**TOWN GRAY**  
**PLANNING BOARD**  
**AGENDA • JUNE 10, 2021**

**Planning Board  
Regular Meeting**

**TOWN OF GRAY, MAINE  
MAJOR SUBDIVISION APPLICATION  
COMMENT RESPONSE LETTER**

DRAWN: MPV/CGB	DATE: JUNE 2021
DESIGNED: CGB/MPV	SCALE: 1"=50'
CHECKED: JAV/CGB	JOB NO. 20-012
FILE NAME:	
SHEET: C-103

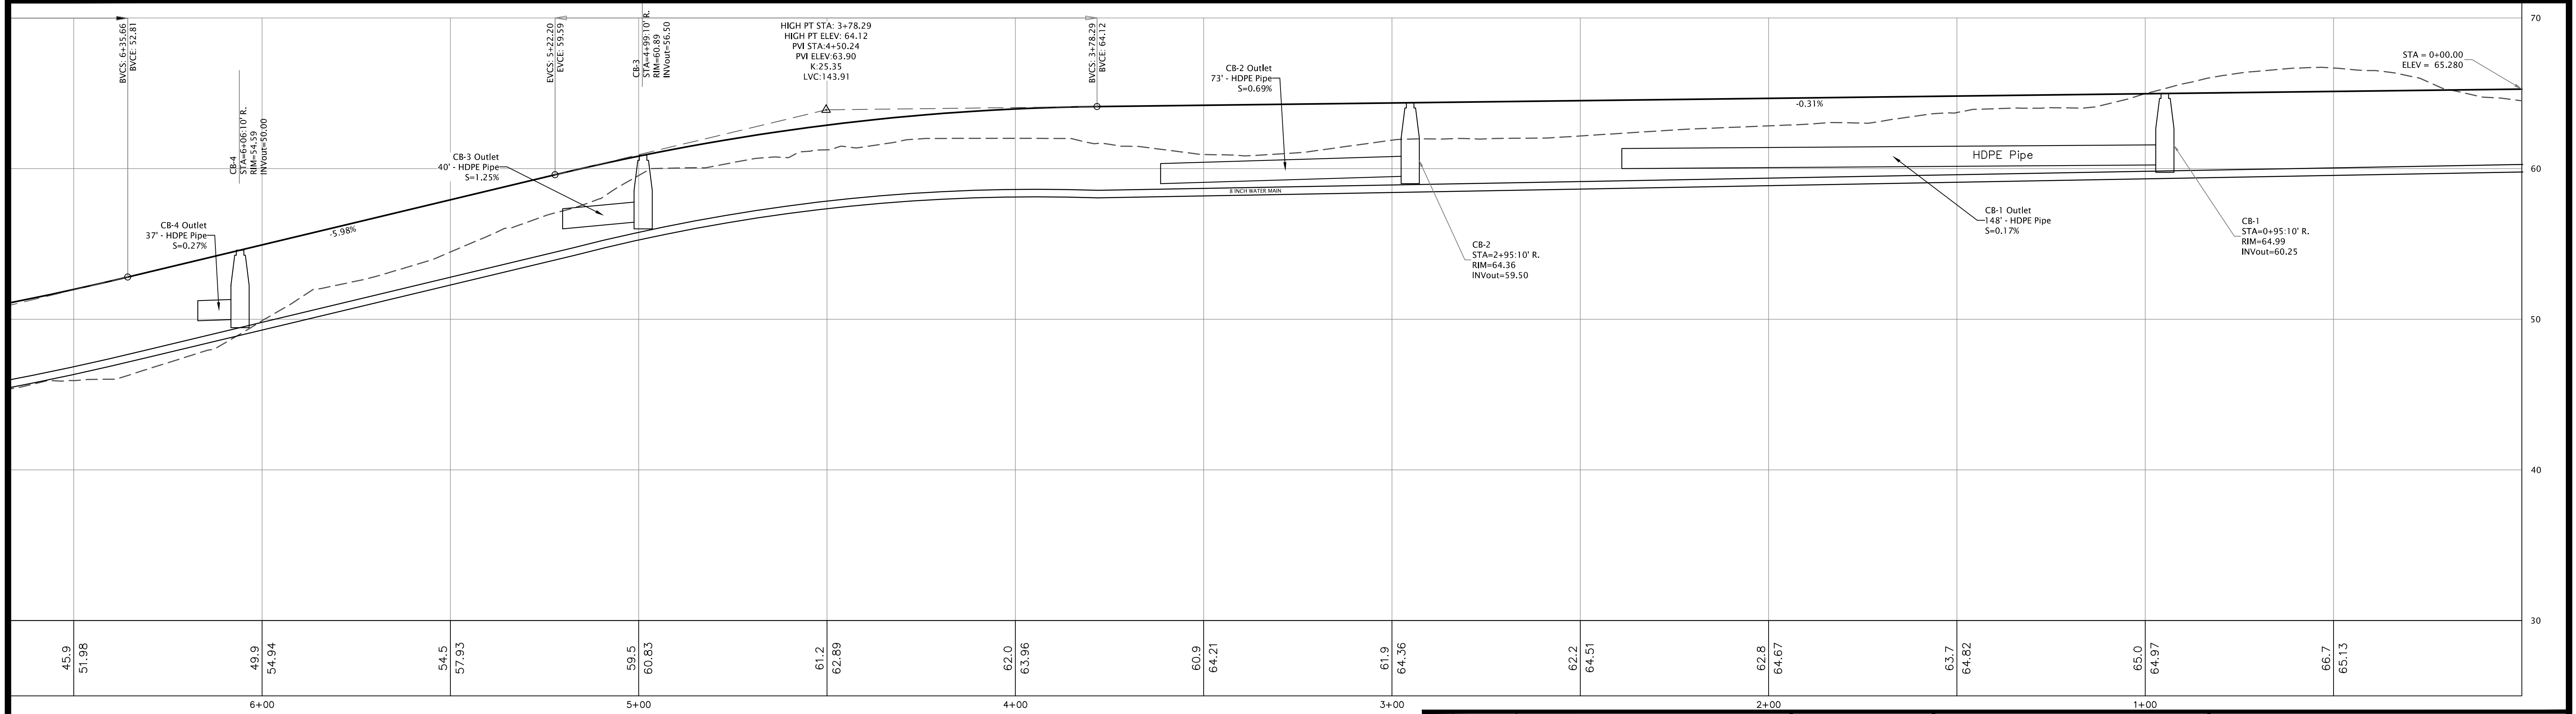
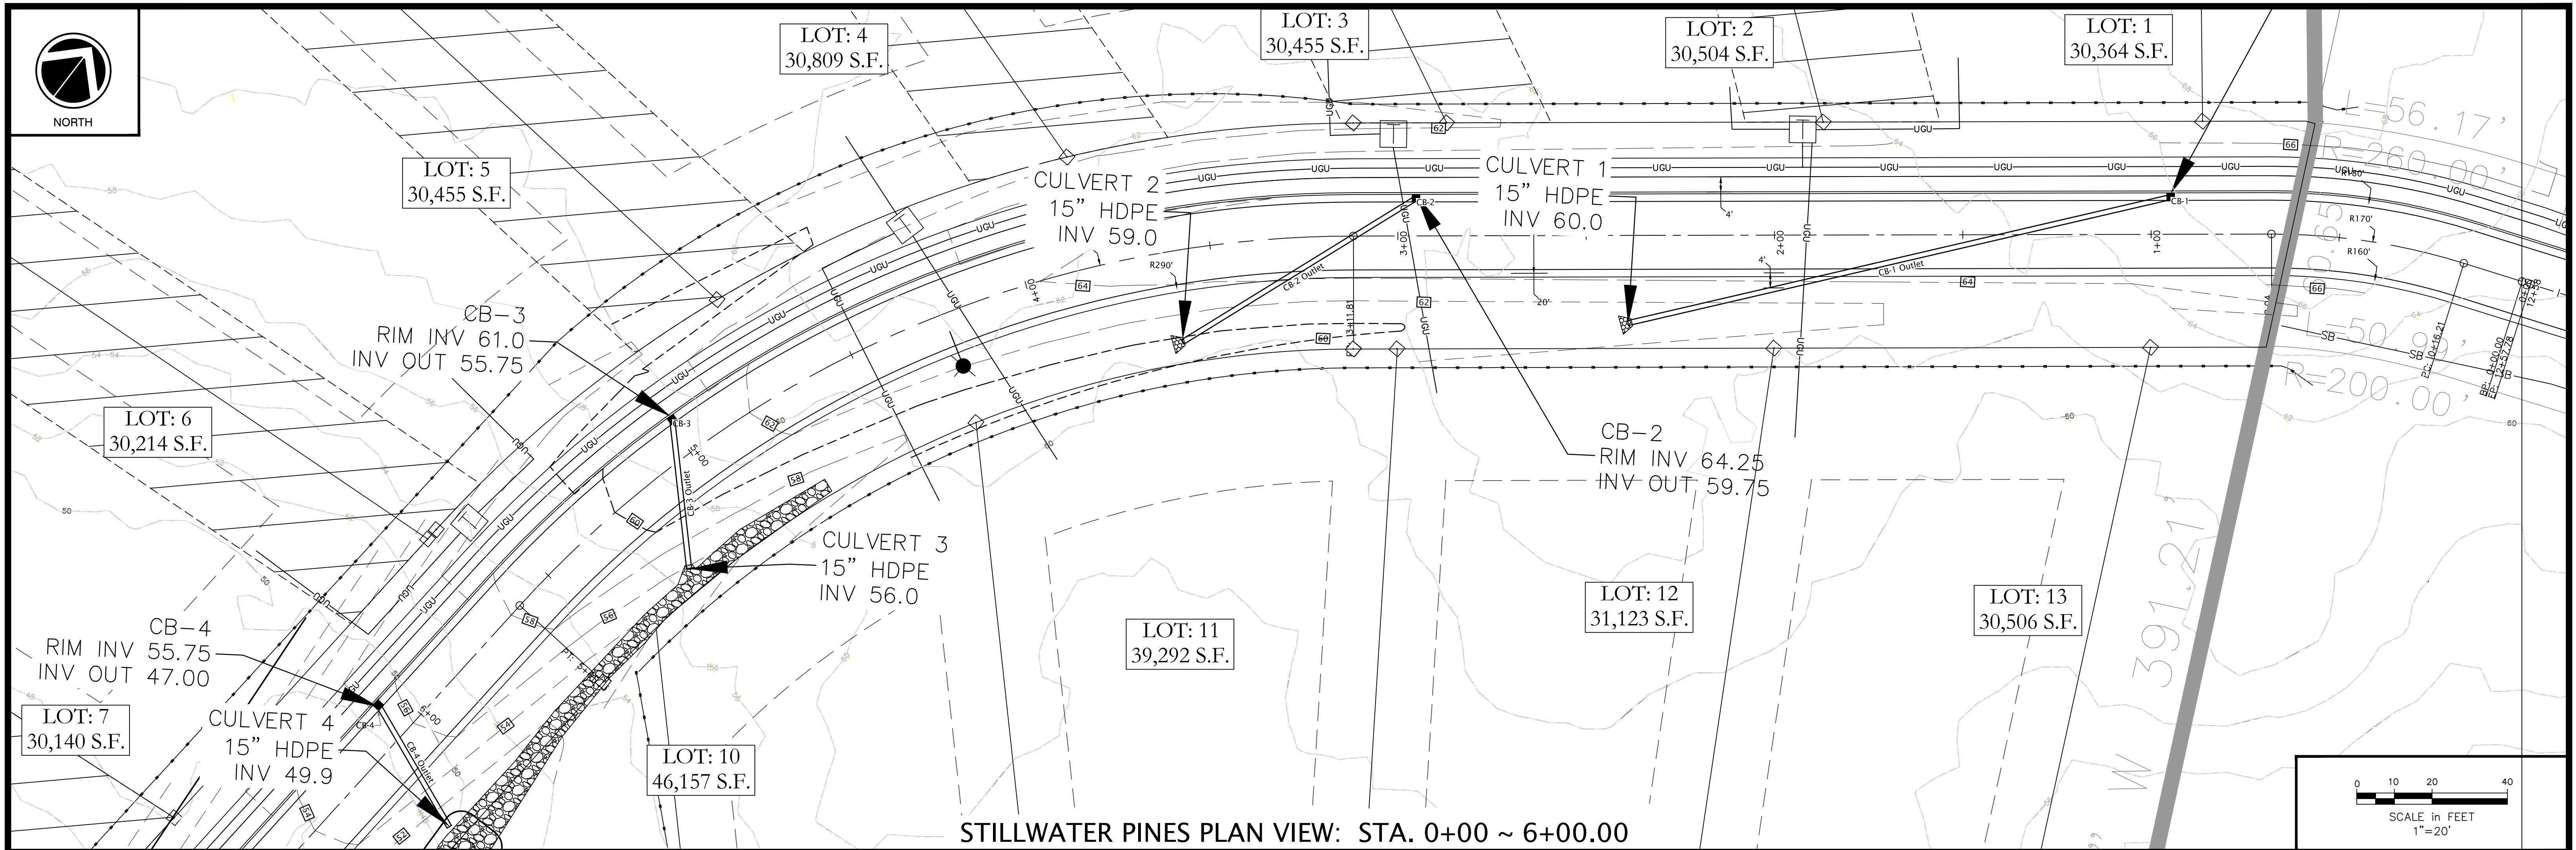
6. The Design Engineer has added sight distance labels at the intersection of Woodcock Drive and Route 115 on Sheet C103. We assume these labels are intended to show the available sight distance. The posted speed limit at this location is 45 mph and the town-required sight distance is 425 feet. It is not clear to us that the required sight distance of 425 feet can be achieved looking to the left when exiting Woodcock Drive, unless significant tree clearing is completed. Also note that there is a 15 foot wide sight distance easement on the Wetmore lot located just to the northwest of Woodcock Drive (shown on C103). It does not appear that the trees in this easement have been cleared. We recommend that a surveyor be retained by the Applicant to confirm the available sight distance in **both** directions from Woodcock Drive and that mitigation measures be proposed if the available sight distance does not meet the requirements. If clearing is required, there needs to be a maintenance requirement that maintains the cleared area in the future.

**The trees were cleared back at the beginning of the project and the site distances taken at the time. The easement has been cleared again and maintenance requirements have been added to the HOA. Wayne Wood was retained to confirm the site distances in both directions and his memo is included as Attachment B.**

**A note dictating the connection to the existing watermain has been included and a profile has been added to C-103.**

Atlantic Resource Consultants
541 US Route One
Freeport, ME 04032
Tel: 207.869.9050
DRAWN: MPV/CEB DATE: JUNE 2021
DESIGNED: CEB/MPV SCALE: N/A
CHECKED: JAV/CEB JOB NO. 20-012
FILE NAME:
SHEET: C-300

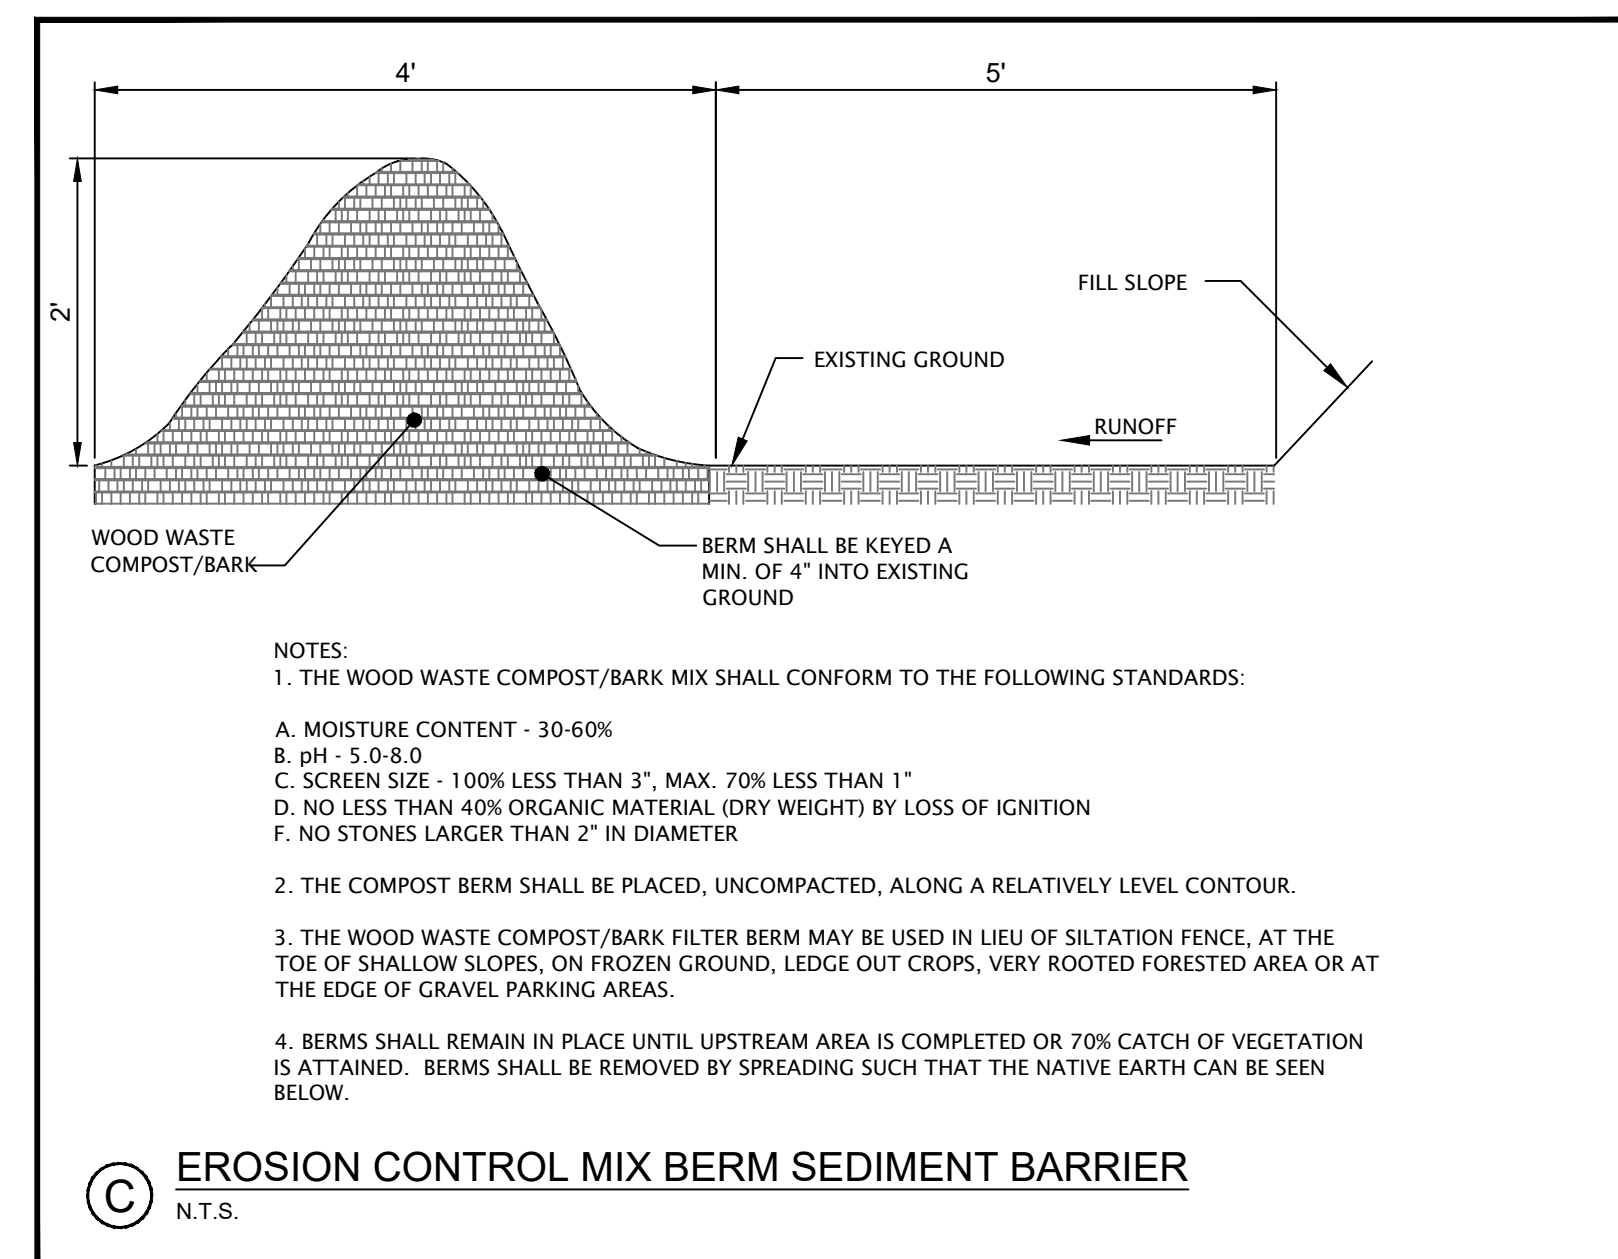
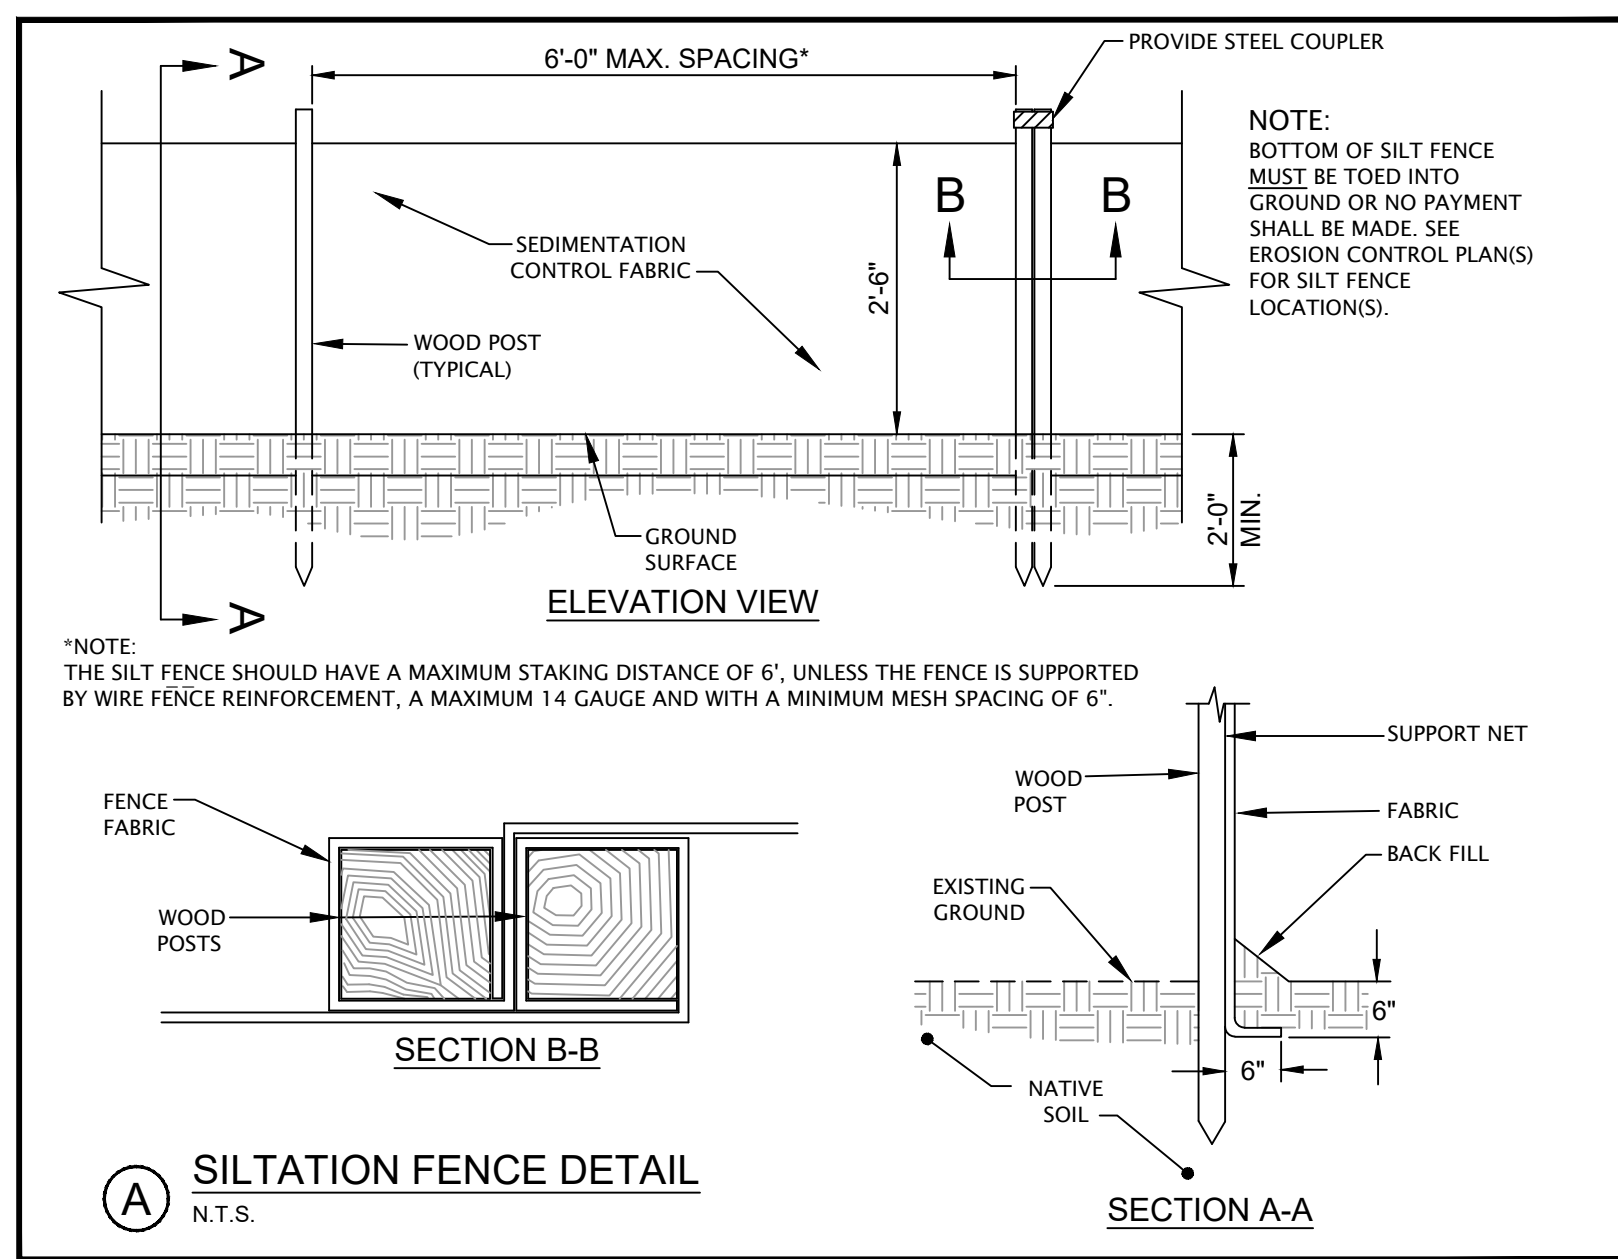
16. Provide a seeding plan for the sedimentation and erosion control plan and plan sheet C300 that lists the seed type and application rates for temporary and permanent seeding for the project.

**A seeding plan was included on C-300 for both temporary and permanent seeding.**
